"WORK PLAN REVISION 2 FOR WORK PLAN ADDENDUM 12 OPERATION AND
MAINTENANCE OF REMEDIATION SYSTEMS AT DAY TANK 1, SOUTH FUEL FARM AND
103RD STREET AND A AVENUE NAS CECIL FIELD FL"
1/11/2008
CH2MHILL CONSTRUCTORS INC

WORK PLAN REVISION

SITE/TASK: Post Active Remediation Monitoring Plan for
South Fuel Farm Facility

DATE OF
REVISION: January 11, 2008

FIGURE 1
 Post Active Remediation Monitoring Locations
 South Fuel Farm
 NAS Cecil Field
 Jacksonville, Florida

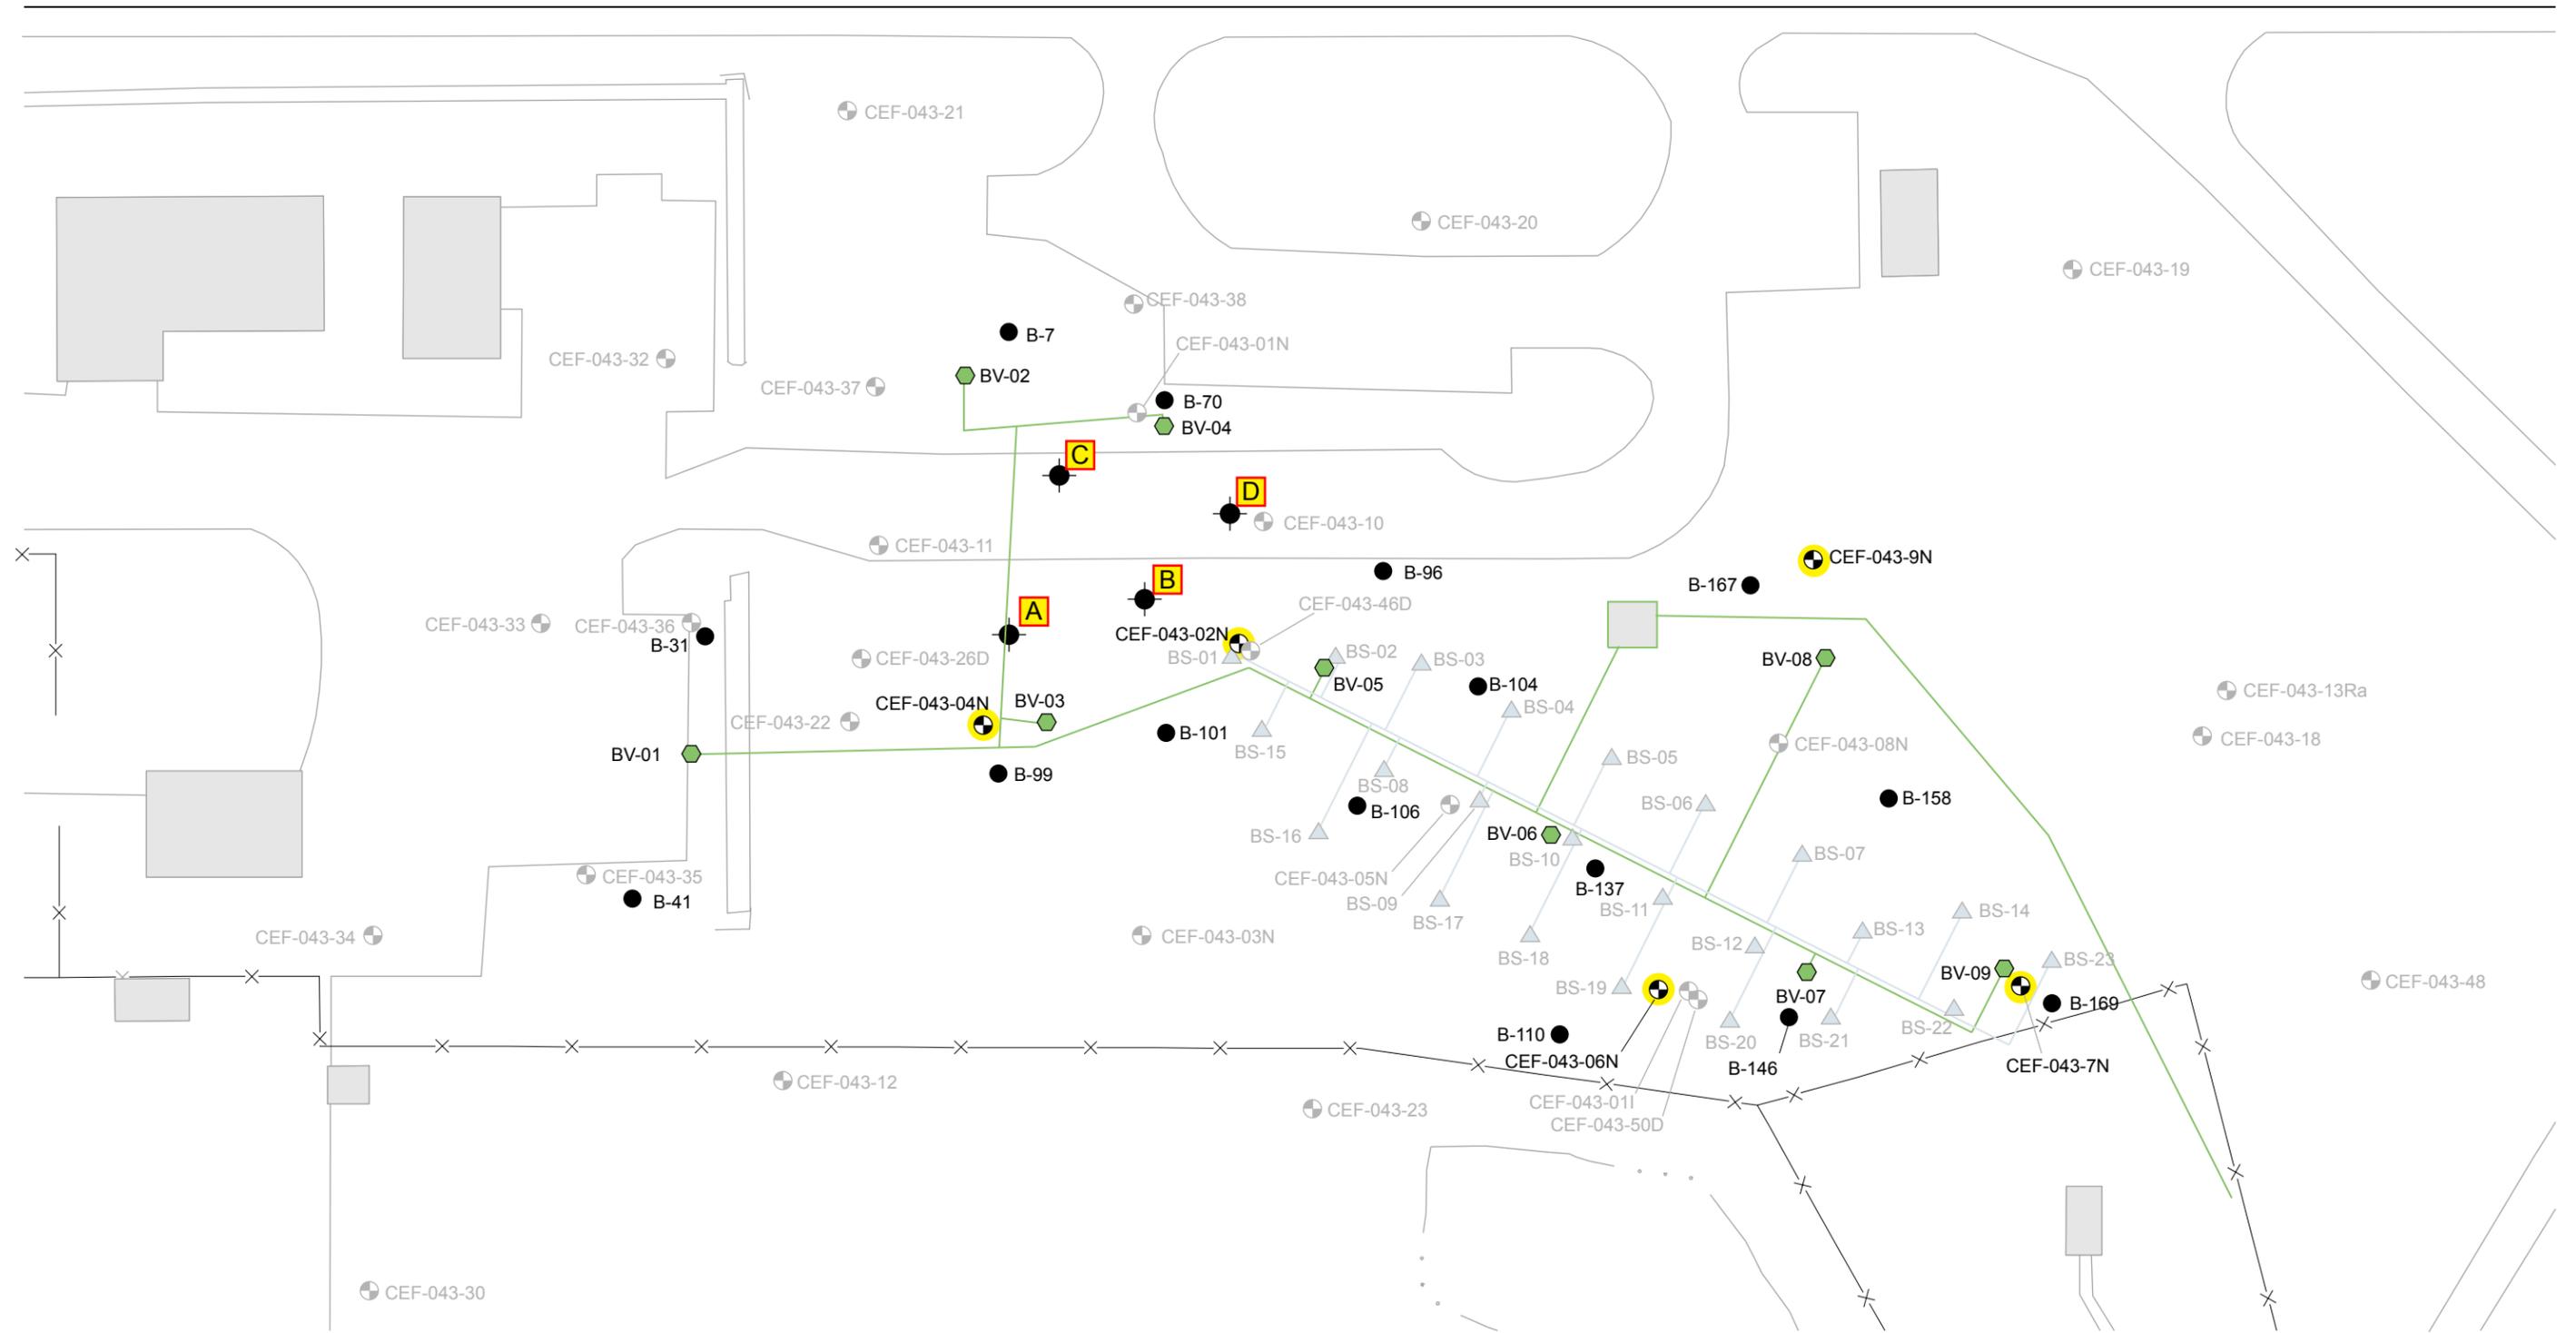
5. Groundwater monitoring will be conducted quarterly for 1 year from wells CEF-043-2N, CEF-043-4N, CEF-043-6N, CEF-043-7N, and CEF-043-9N. These monitoring well locations are shown on Figure 1 of the attached TM. Sample collection activities and laboratory analyses will be performed as described in the SAP.
001	Table 3-2, Sampling and Analysis Summary Table Revised to include the additional 4 soil borings (sample identifications appended with A, B, C, and D) in the area between biosparging well BS-1 and bioventing well BV-4 and the surface soil sampling at borings B-41, B-96, B-101, B-104, B-106, B-146, and B-167. The site-specific sampling event, sampling and analytical requirements, and required level of data quality objectives and data packages are provided on the attached Table 3-2, Revision No. 01 (R01).

1. Soil samples will be collected from additional sample locations in the area in the between biosparging well BS-1 and bioventing well BV-4 (Figure 1).
2. Groundwater monitoring will be performed on a quarterly basis for 1 year.
3. Any soil sample in which total recoverable petroleum hydrocarbons (TRPH) is detected at a concentration above the residential SCTL, will be analyzed for Total Hydrocarbon Criteria Working Group Analyses (THCWGA) to determine if individual fractions of TRPH are above the residential SCTLs.

Soil samples will be collected from within close proximity of the original 15 soil borings (B-7, B-31, B-41, B-70, B-96, B-99, B-101, B-104, B-106, B-110, B-137, B-146, B-158, B-167, and B-189) described in the SAP. An additional four soil borings (sample identifications appended with A, B, C, and D) in the area in the between biosparging well BS-1 and bioventing well BV-4 will be added as part of the post-active remediation sampling monitoring. In addition, surface soil samples will be collected from 0.5 to 2 feet below ground surface at original boring locations B-41, B-96, B-101, B-104, B-106, B-146, and B-167 to confirm that surface soil concentrations are below SCTLs. These sample locations were selected because elevated total recoverable petroleum hydrocarbon (TRPH) concentrations

were historically detected in subsurface soils at these boring locations. The soil samples will be collected on an annual frequency beginning in January 2008. The soil boring locations are shown on Figure 1. Sample collection activities and laboratory analyses will be performed as described in SAP.

Groundwater monitoring will be conducted quarterly for 1 year at wells CEF-043-2N, CEF-043-4N, CEF-043-6N, CEF-043-7N, and CEF-043-9N. The monitoring well locations are shown on Figure 1. Sample collection activities and laboratory analyses will be performed as described in the SAP.
